1992 Corvette: Recall: Instrument Panel/Left Hand Lower Trim/Brake Pedal Interference

Subject: PRODUCT CAMPAIGN 92C10 - INSTRUMENT PANEL LEFT HAND LOWER TRIM PANEL/BRAKE PEDAL INTERFERENCE

Model and Year: 1992 CHEVROLET CORVETTE

Bulletin Number: 92C10 - (04/23/1992)

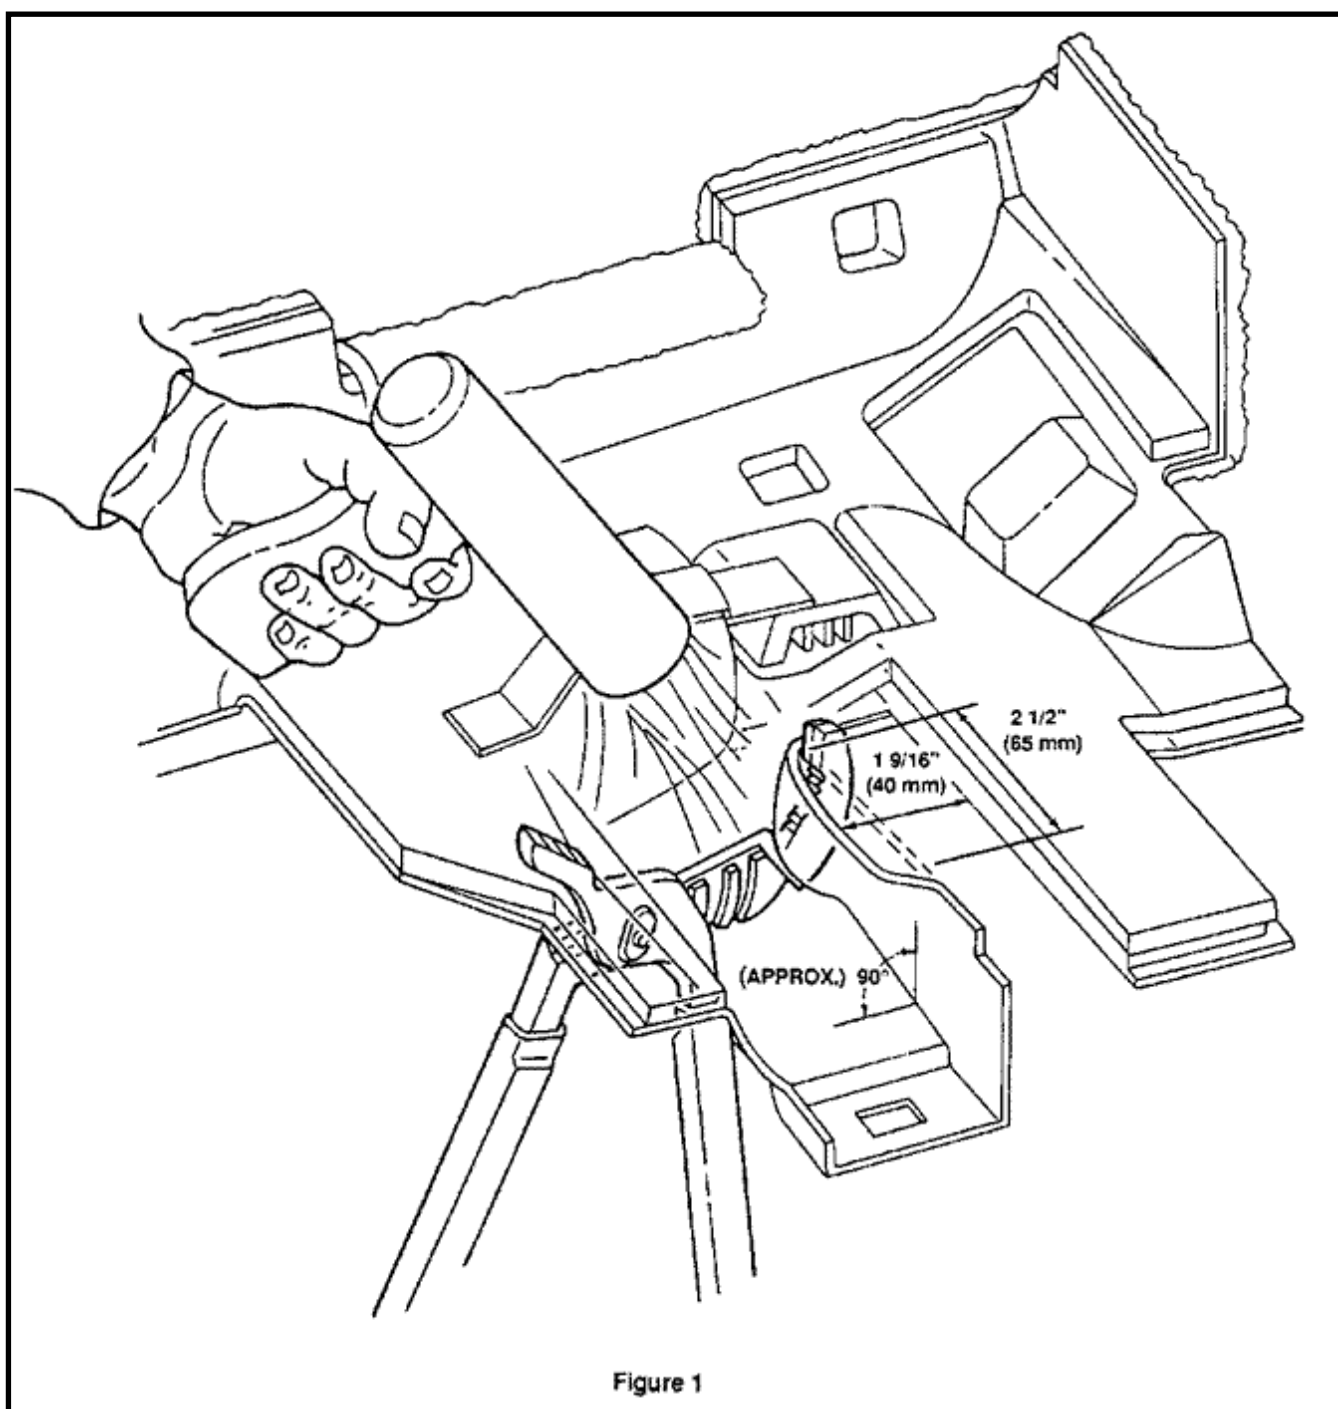
1. Remove I/P left-hand lower trim panel (per Preliminary Service Manual, Section 8C-33).
2. Lift away foam sound deadener from area shown in Figure 1 and tape out of way.
3. Using a heat gun, warm trim panel area shown in Figure 1. **USE CARE TO WARM COMPLETE AREA EVENLY.**
4. Using Channel Locks size 16 or larger, place near upper left-hand corner of I/P left-hand lower trim panel as shown in Figure 1. Quickly reform brake pedal opening to configuration and dimensions indicated in Figure 1. If necessary, Channel Locks may be moved downward during initial reforming and/or steps 3 and 4 may be repeated to obtain minimum clearance of 2mm between brake service pedal arm and I/P left- hand lower trim panel.
